Clerk's Contract and Agreement Cover Page

Contract Description: Main Pumping Station - East Reservoir Addition

CONTRACT CHANGE ORDER NO. 1

OWNER: Village of Orland Park, Illinois
 CONTRACTOR: Joseph J. Henderson & Son, Inc.
 P.O. Box 9
 Gurnee, IL 60031
 CONTRACT: East Reservoir Addition

SUPPLEMENTARY
 DRAWING SD01

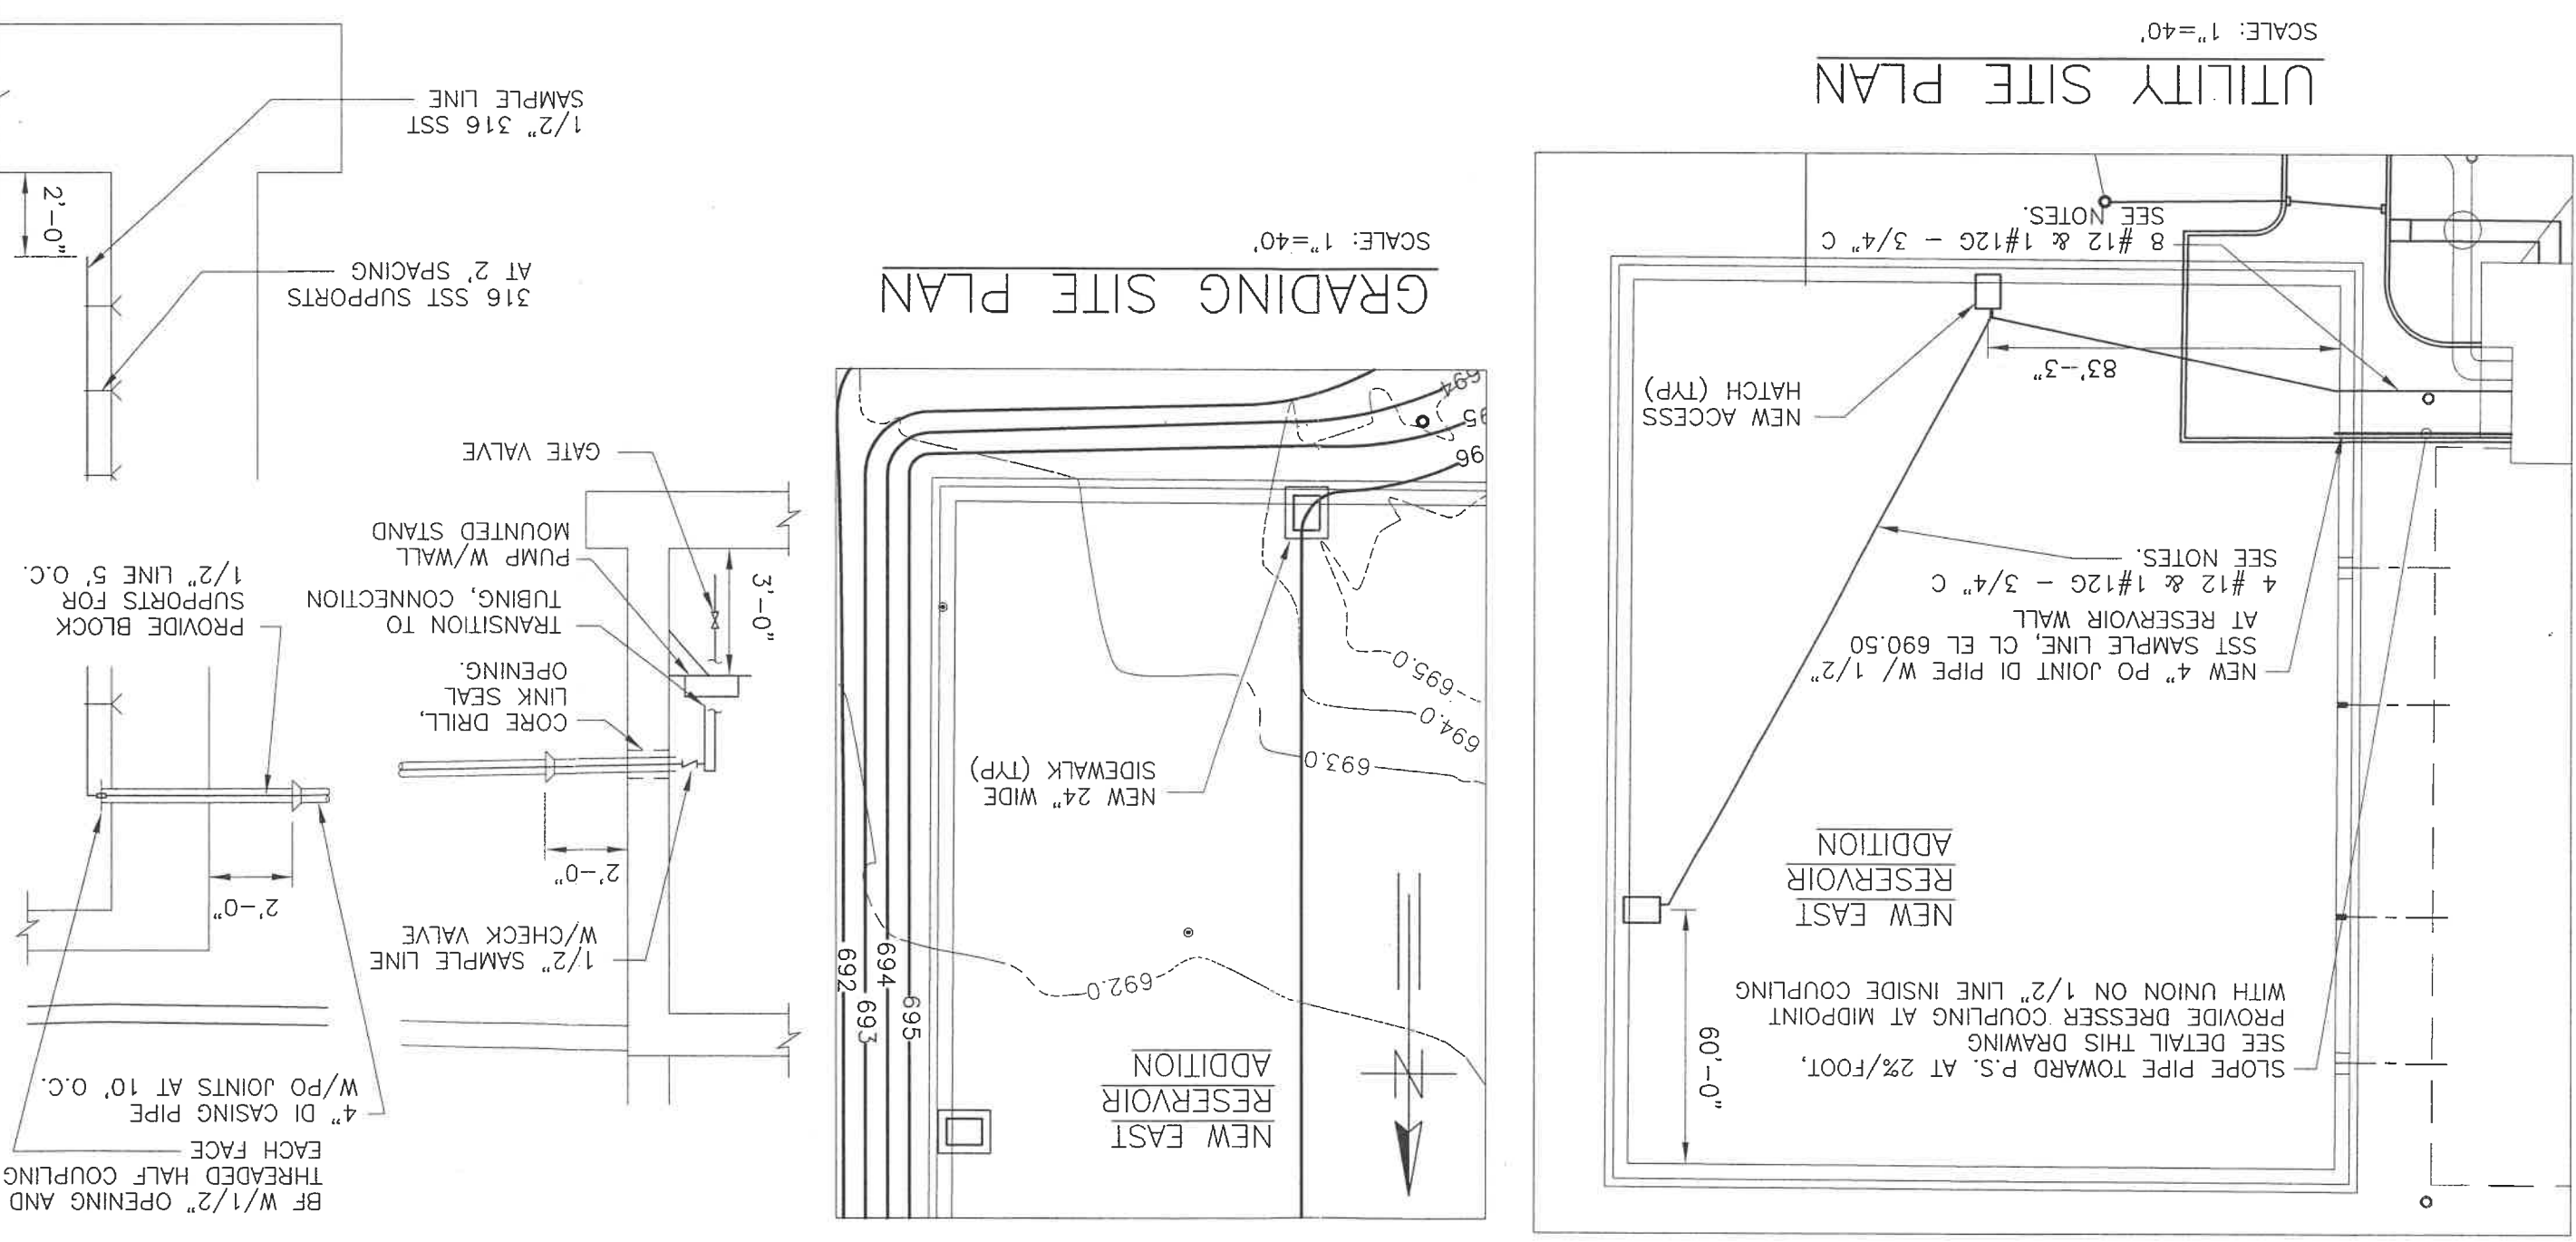
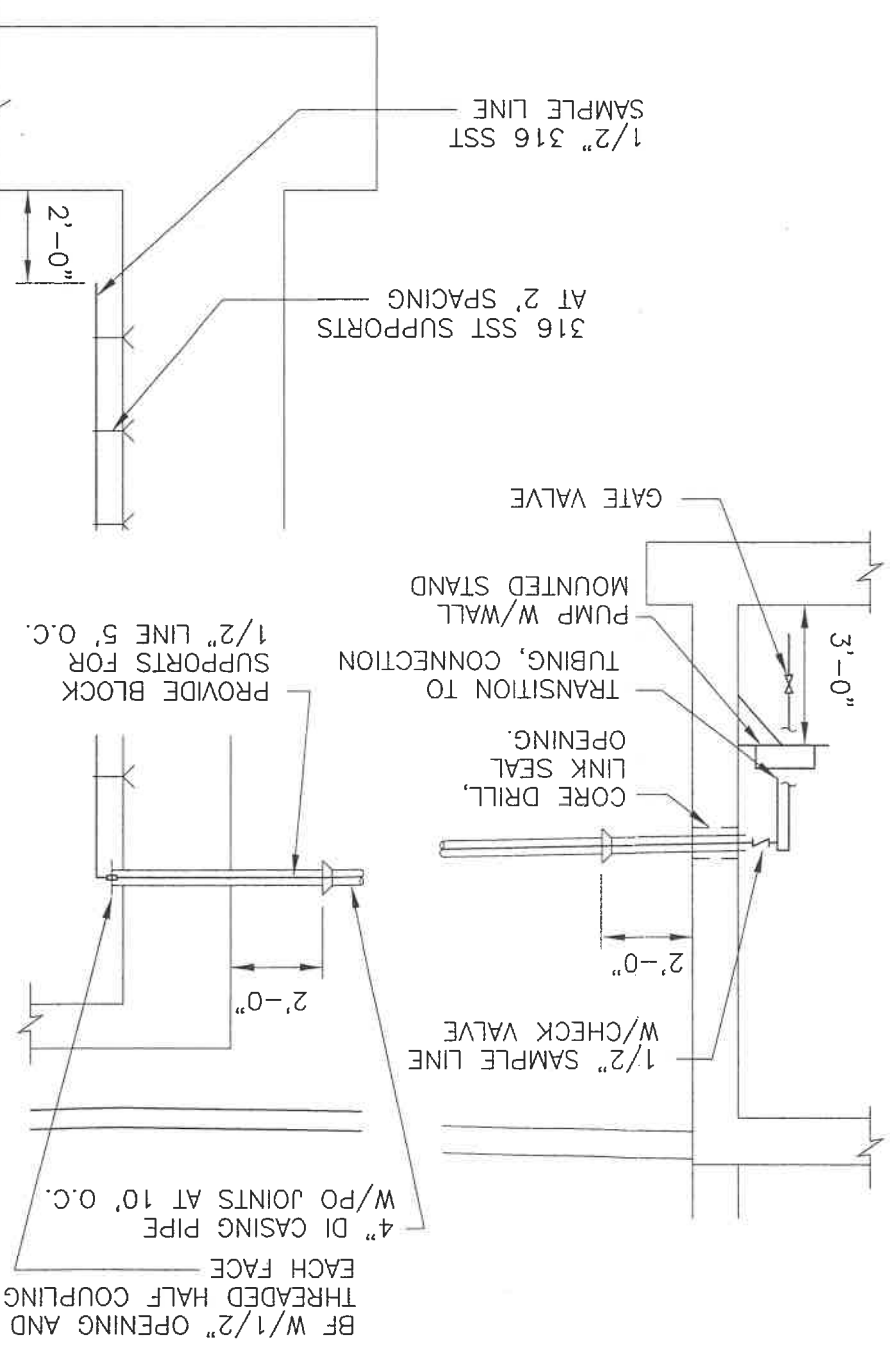
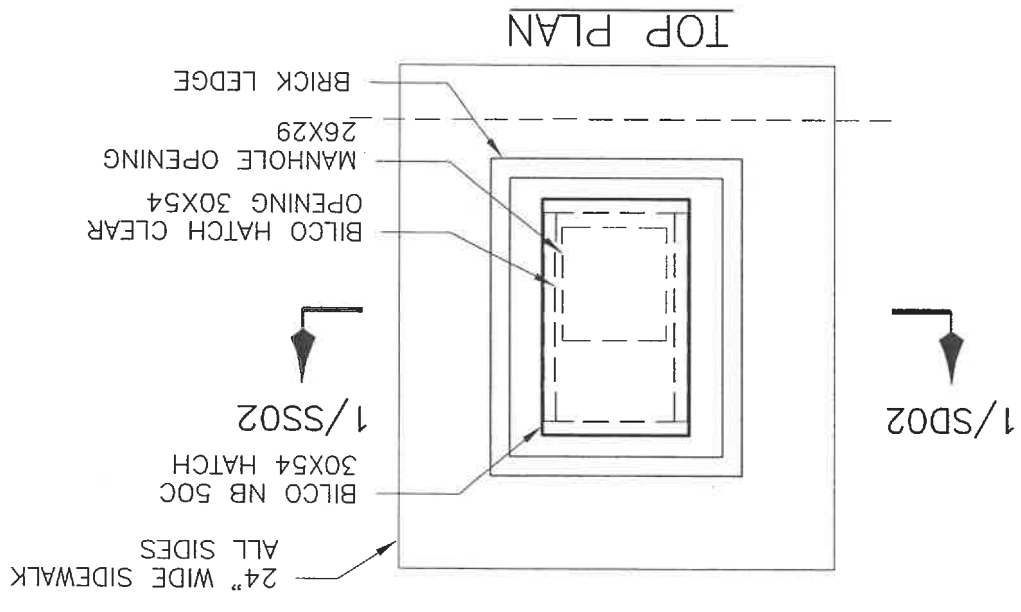
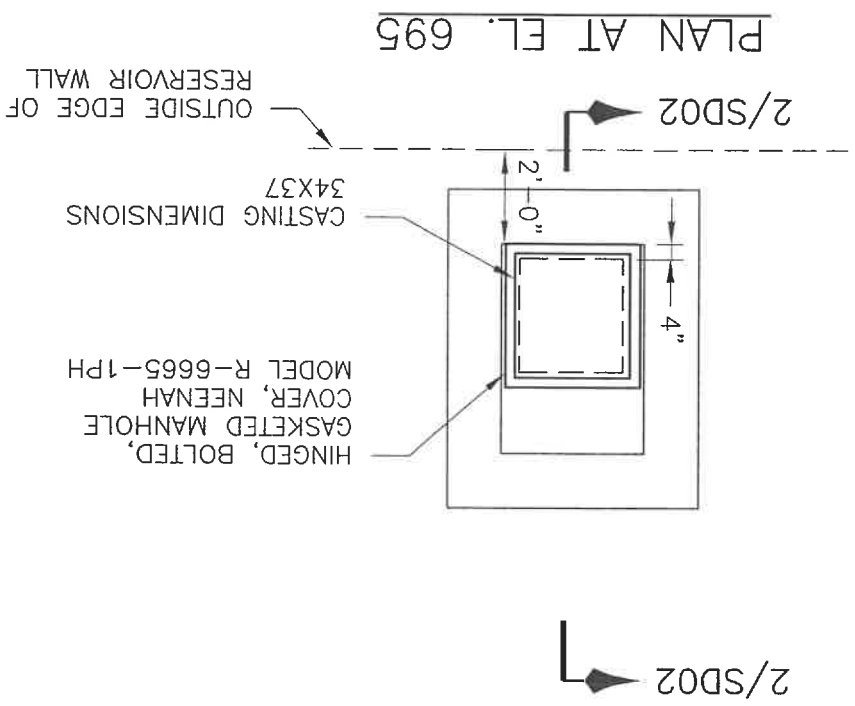
3. In order to obtain a permit to construct and operate, the Illinois Environmental Protection Agency required modifications to the project design including: addition of two access locations to the new East Reservoir Addition with above grade hatches and associated pump shelf, and associated electrical work. The two access hatches in the top slab replaced two of the three concrete slab openings, and were tied into the Main Pump Station Alarm System. The sampling pump was installed inside the Main Pump Station and sample line installed connecting the sampling pump to the new East Reservoir Addition to provide the Owner the ability to sample the water in the new East Reservoir. These modifications were added following acceptance of bids for the project. At the request of the Engineer and the Owner, JJH performed the requested work, which is documented in the Extra Work Order dated July 1, 2009. This work results in an increase in the Contract Price of\$51,944.87

Item No. 3 Joseph J. Henderson & Sons, Inc. Extra Work Order dated 07/01/2009
Supplemental Drawing SD01 "Reservoir Hatches" dated June 2009
Supplemental Drawing SD02 "Hatch Details" dated June 2009
Specification Section 04050 "Masonry Mortar and Grout"
Specification Section 04300 "Masonry"
Specification Section 07620 "Sheet Metal Flashing and Trim"
Specification Section 07724 "Access Hatches"
Specification Section 11318 "Sampling Pump"
Specification Section 15061 "Sampling Piping and Accessories"
Email from Beth Vogt dated 04/28/2009

FILE NAME	14601-S2
DWG	S2
SHEET	6 OF 9
DATE	MARCH 2008
REV	0

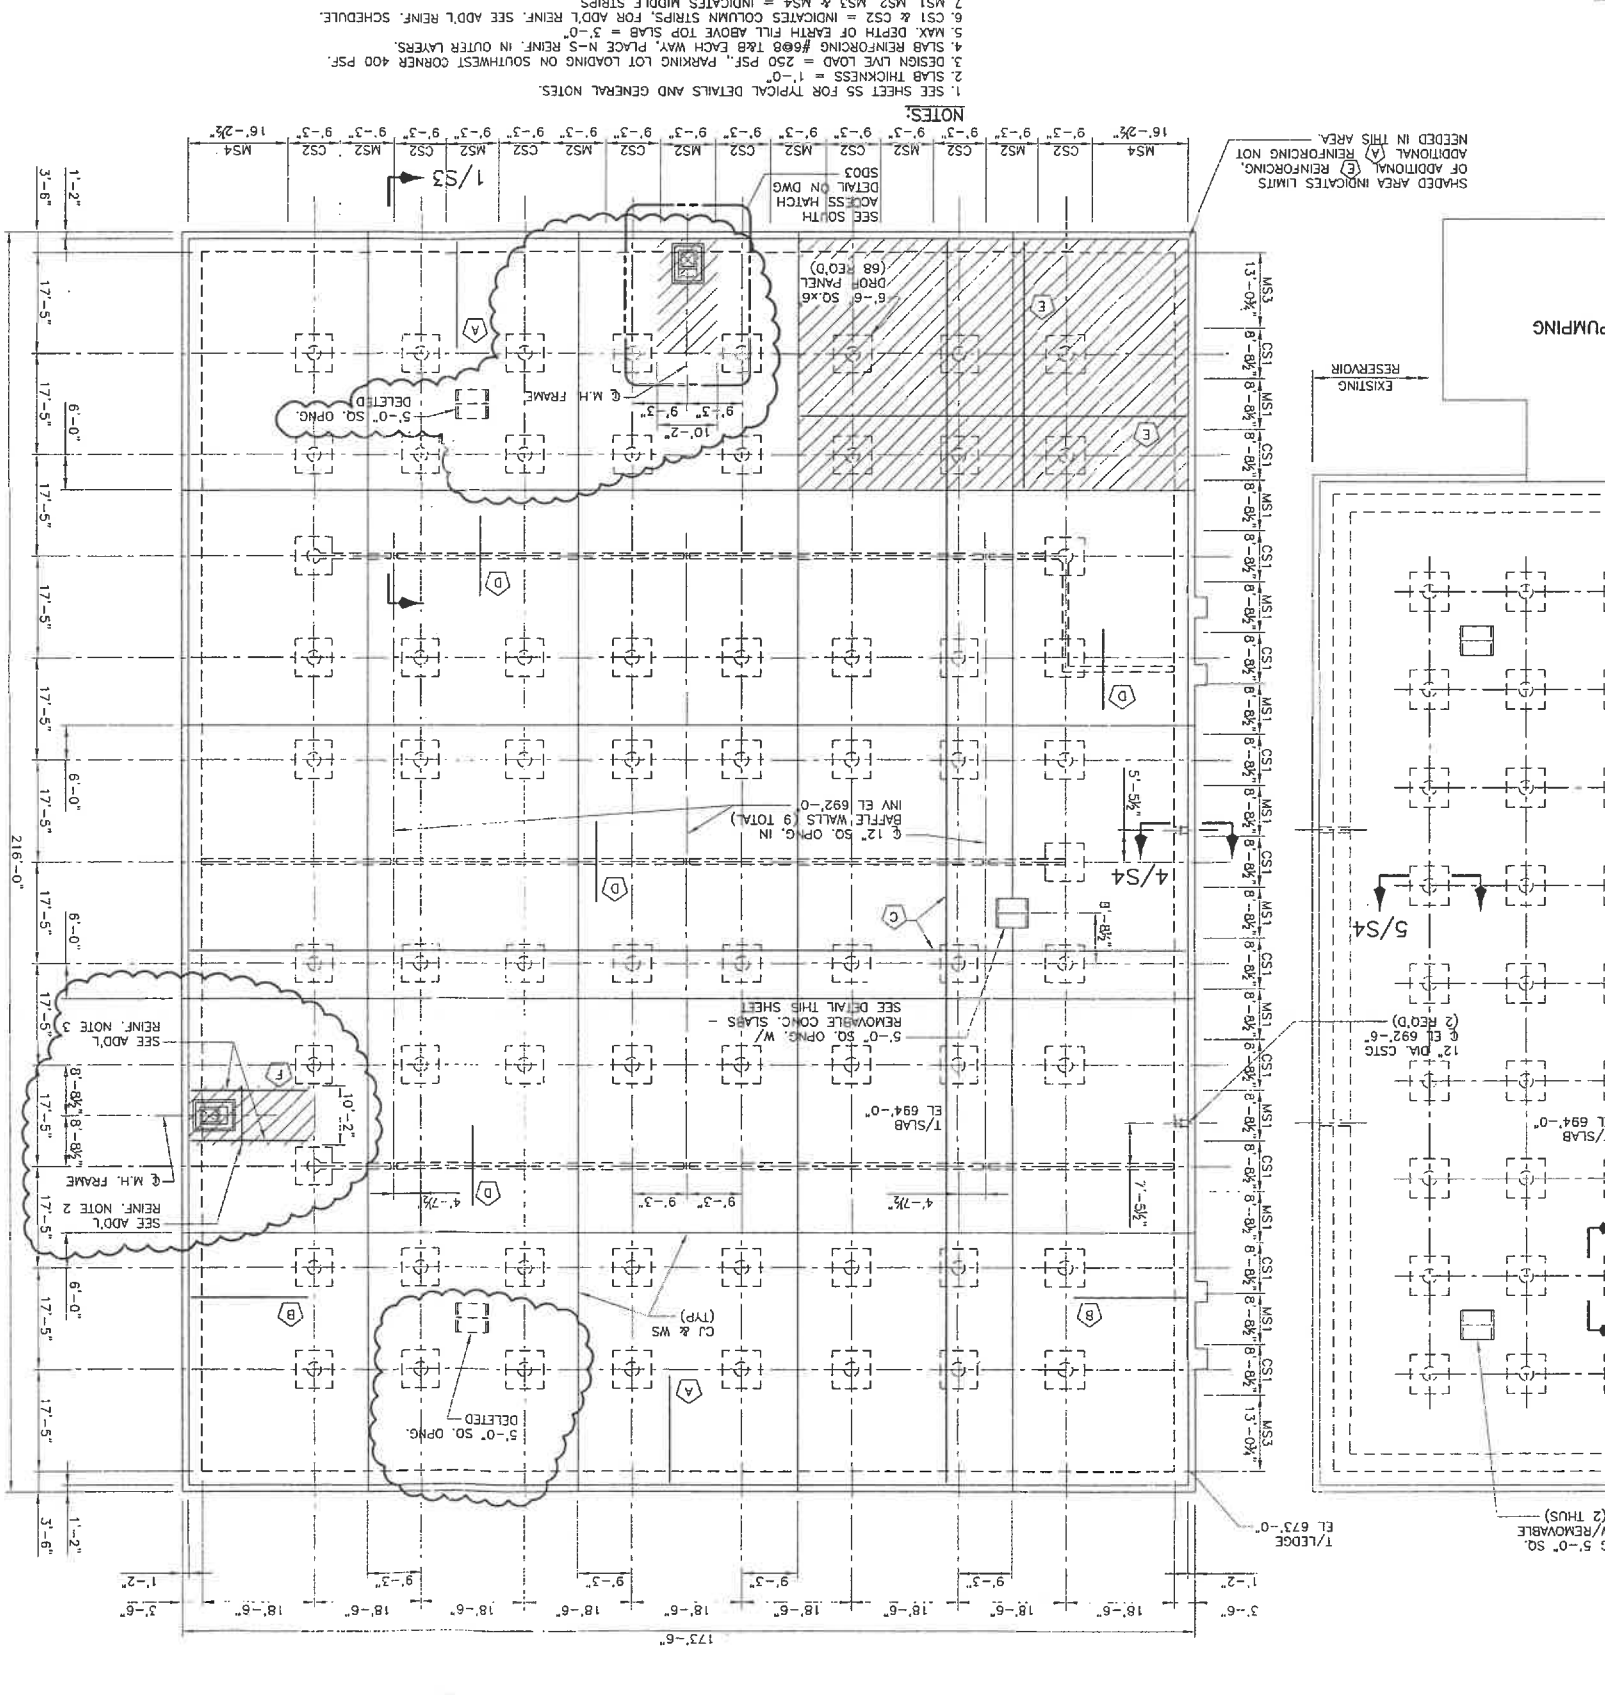
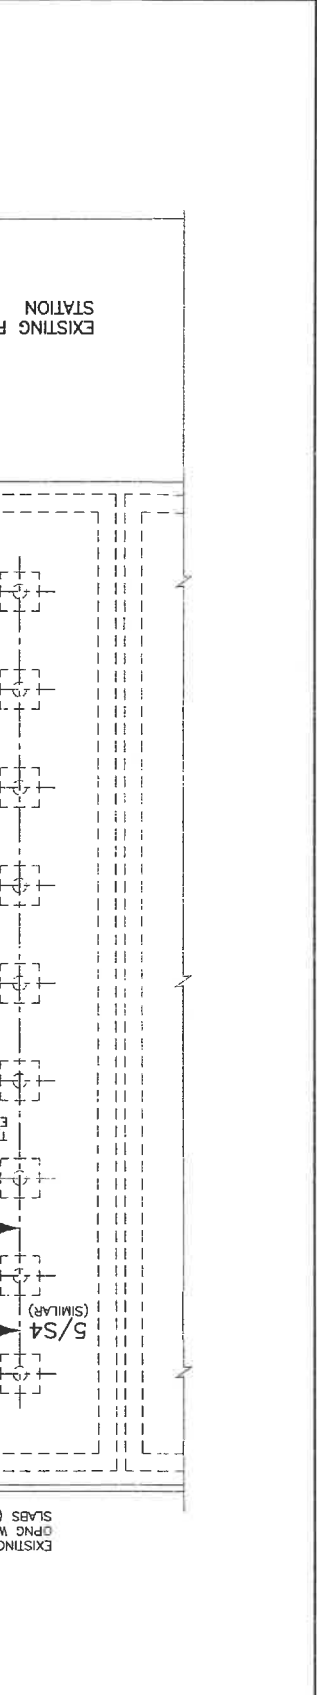
The revisions to Drawing S2 that are bubbled answers the locations questions and SD03 gives the orientation.

2. WHERE WILL THE OTHER CASTING IN "P" BE LOCATED?
Answer: The new casting in P is 8'-8.5" from each column line and needs to clear the wall below. See revised drawing S2.
